# 802.3da TCI Clause 188 and Clause 189

Stephan Schreiner  
Rosenberger Hochfrequenztechnik GmbH & Co. KG  
September 2025

Version – Prototype 1 (Material A), 27pF

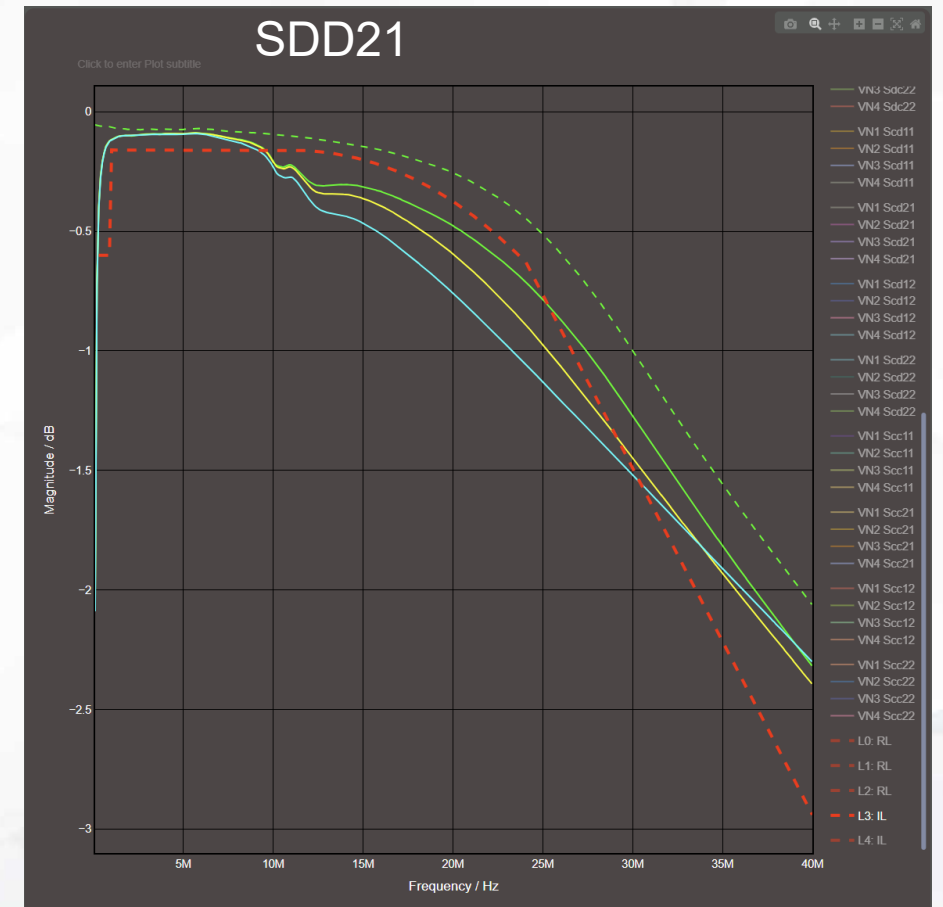
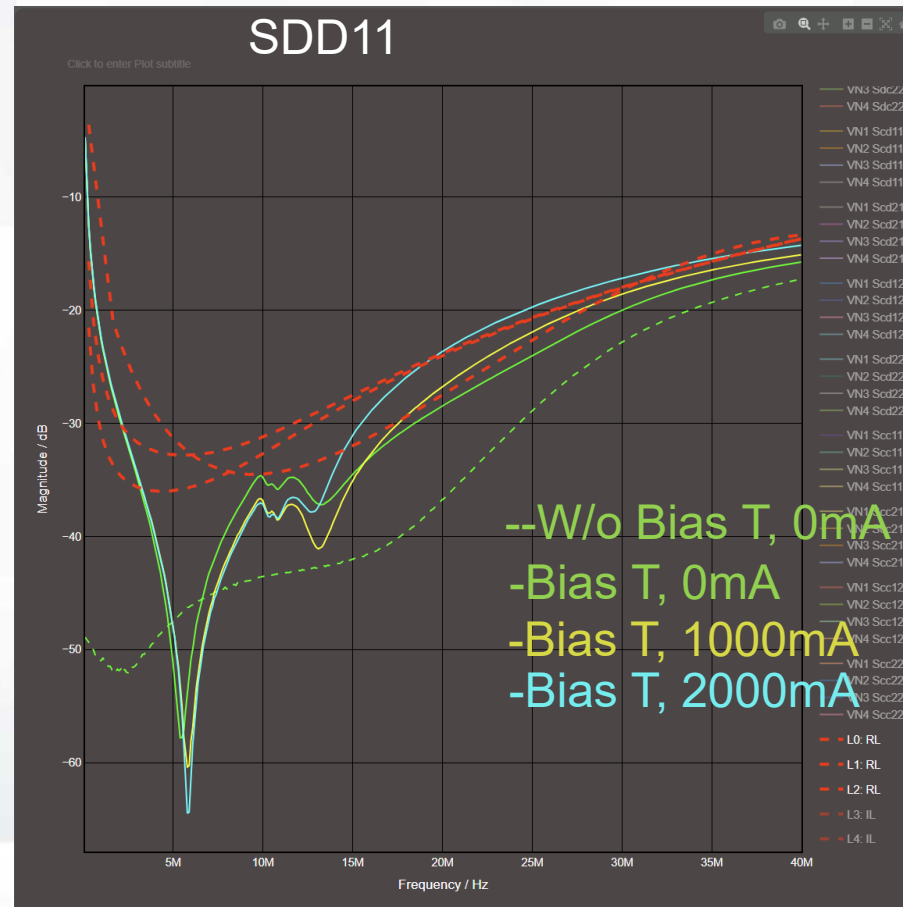
- Small Ferrite
- Bias T shows significant influence in Return Loss and Insertion Loss
- Insertion Loss increases by DC Load
- Shows issues in Return Loss at higher currents, however influence of Bias T is unclear

Version – Prototype 1 (Material A), 22pF

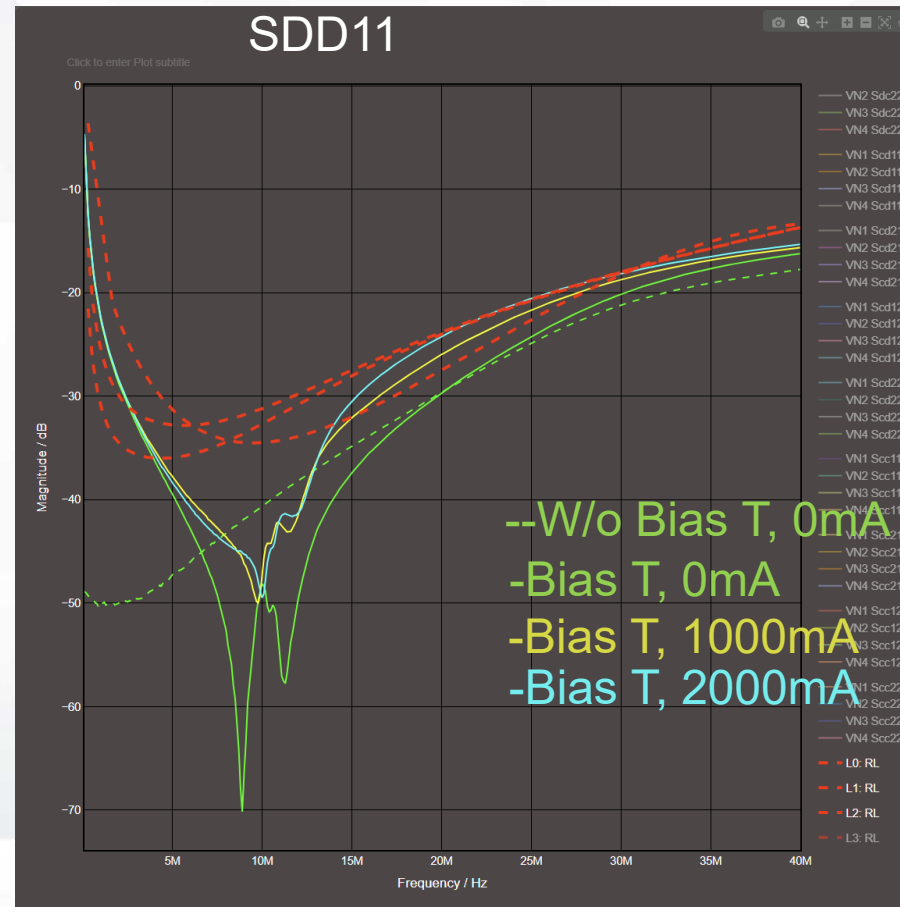
- Small Ferrite
- Reduced capacitance to compensate brings RL into feasible range (still to less margin)
- Insertion Loss increases by DC Load

## Prototype 1, Unscreend Implementation vs. Screend Implementation (Logarithmic Frequency Axis)

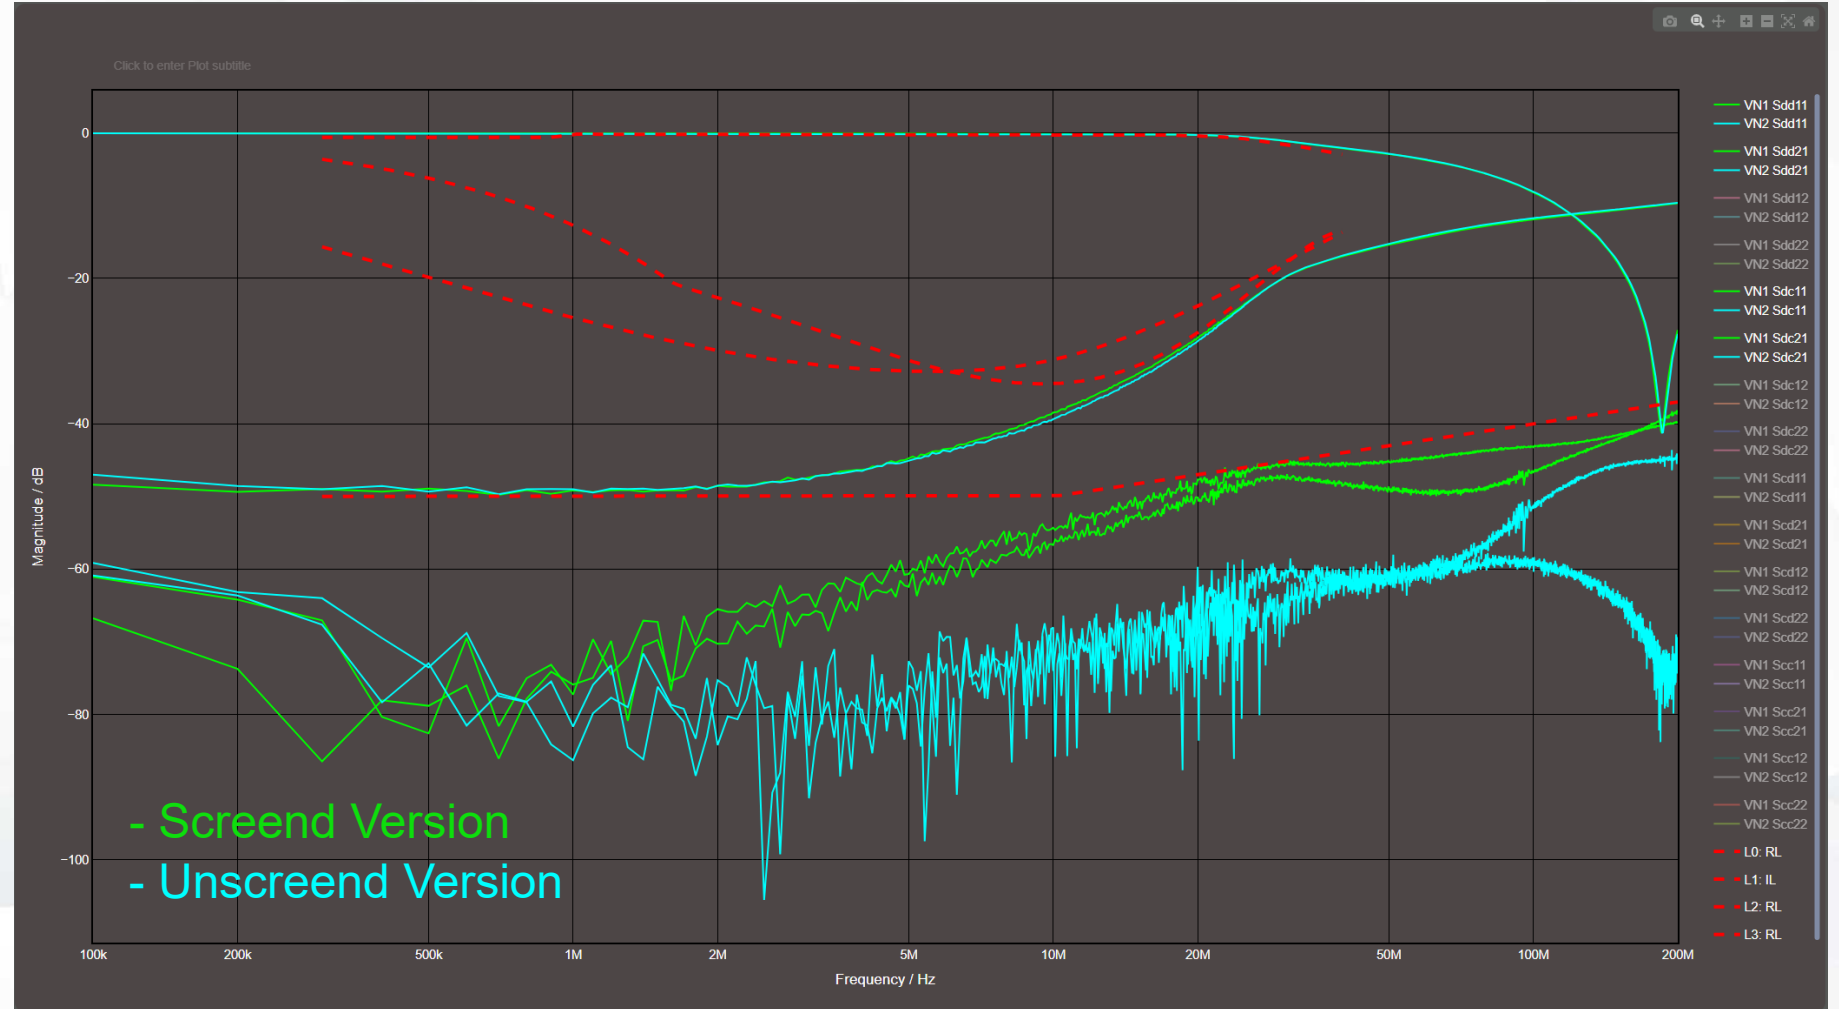
- Unscreend Version shows enough margin for series production
- Screend Version is close to the MCL Limit
